# Central Peak Mixed Use Condominiums

Design Review  
Design Response Conference

# PREFERRED OPTION - BOARD FEEDBACK

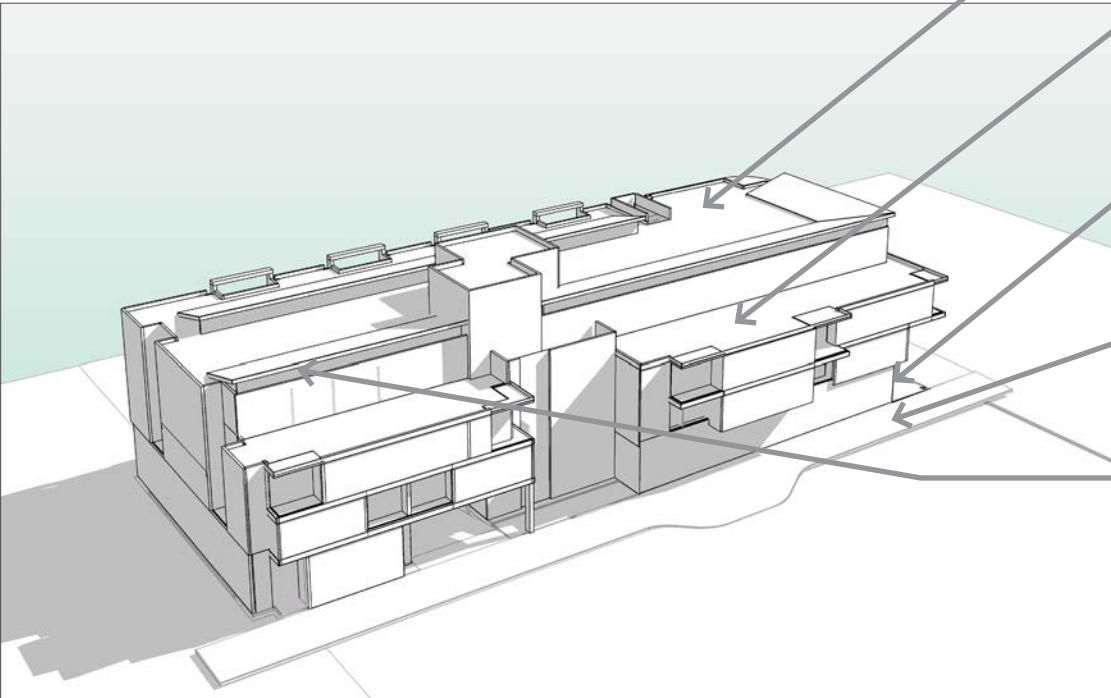
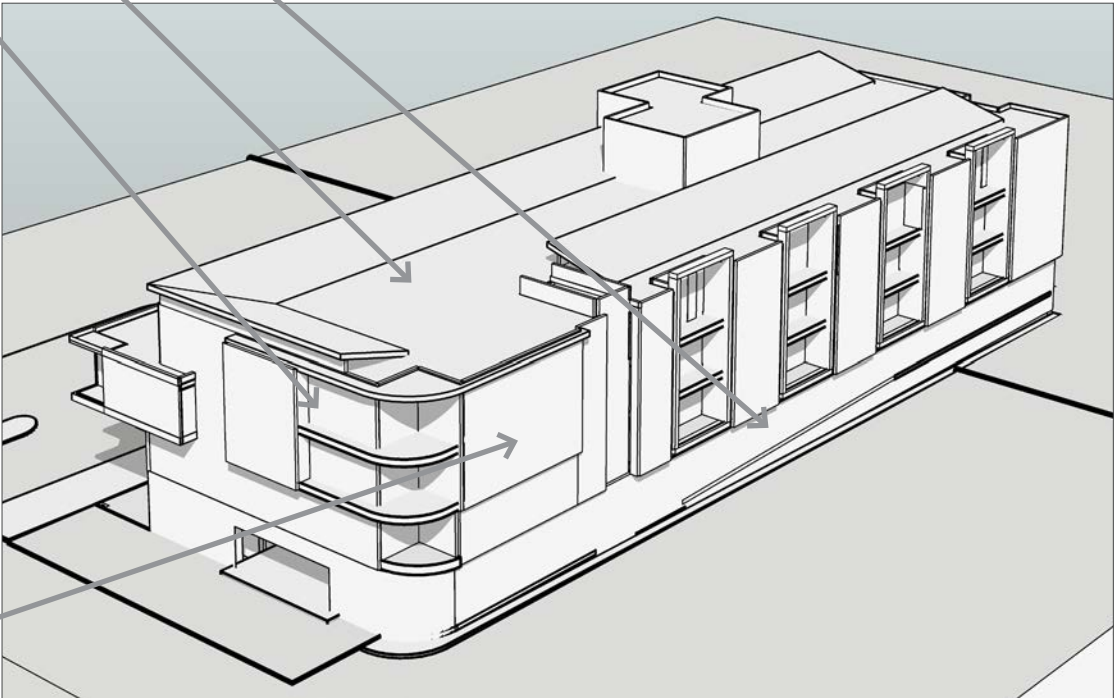
Provide vertical modulation to add variety and visual relief to the long facade.

Centrally located, pedestrian-oriented plaza open to the sky enhances the building modulation and reduces the apparent mass of the building.

Use corner Plaza for visual punctuation and enhanced pedestrian environment

Provide public improvements and site features such as lighting, benches, and other elements that enhance the character of the frontage.

Address Blank Wall treatment - potential canvas for art, murals or landscaping

Give design consideration to rooftop and terrace elements as this will be visible from neighboring buildings.

Implement design techniques to reduce mass of building and introduce elements that support a good human scale. Give careful consideration to fenestration patterns and deck placement and size.

Provide pedestrian oriented elements including weather protection, amenities, human scale elements, and pedestrian-friendly building fronts.

Provide a sidewalk width to accommodate a Movement zone. Minimize fixed elements and landscape planters that may interfere with pedestrian movement.

Emphasize horizontality of the building with a strong base and a visually distinctive roof line treatment

Give thoughtful consideration to alley facade anticipating future residential development to the south and an alley way that serves as more than just a utilitarian function.
